Temporary Maintenance Instruction TMI 139-567

Tachometer (MT34) - Install procedure.

All AW139 Helicopters

This TMI provides the instructions and requirements to perform the Tachometer (MT34) - Install procedure.

Figure 1 (Sheet 1 of 2) Accelerometer (MT34) - Install procedure

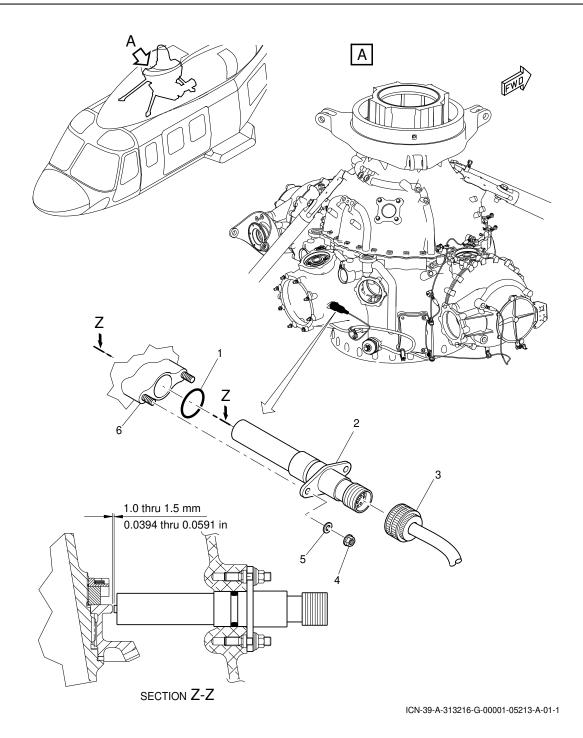
- 4 Dry the parts you cleaned with the compressed air until you remove all the solvent.
- If this is not the first installation on MGB, continue with the step 7.
- If this is the first installation on MGB, do as follows:
- 6.1 If the tool P/N 3G6320A00134A670B (7) is not available continue with the step 7.
- 6.2 If the tool P/N 3G6320A00134A670B (7) is available, temporarily install the tachometer (2) without its packing in the main gearbox (6). Do not torque the nuts (4) at this time.
- 6.2.1 Make sure the clearance between the prod of the tachometer (10) and the gear tip (9) is 1.00 thru 1.5 mm (section Z-Z, Figure 1).

6.2.2 Calculate the clearance (11, Figure 1) applying the formula (B - C) - A = 1.0 / 1.5:

6.2.3 Record the real calculated clearance:

- If the clearance is in the limits, continue with the step 7.
- If the clearance is not within the limits, replace the tachometer (2) with a new item and do steps step 6.2.1 thru step 6.2.3 again.
- 7 Lubricate the new Packing, preformed (31-32-01-01 -006) with the Grease (C115).
- Put the packing (1) in the related groove of the tachometer (2).
- 9 Install the tachometer (2) in its housing on the main gearbox (6).
- Attach the tachometer (2) to the main gearbox (6) with the two washers (5) and the two nuts (4).
- Torque the two nuts (4) to 3.4 thru 4.5 N m (30 thru 40 lbf in).
- 12 Apply the Sealing compound (C065) on the parts that follow:
 - On the mating edge between the tachometer (2) and the main gearbox (6)
 - On the washers (5) and the nuts (4).
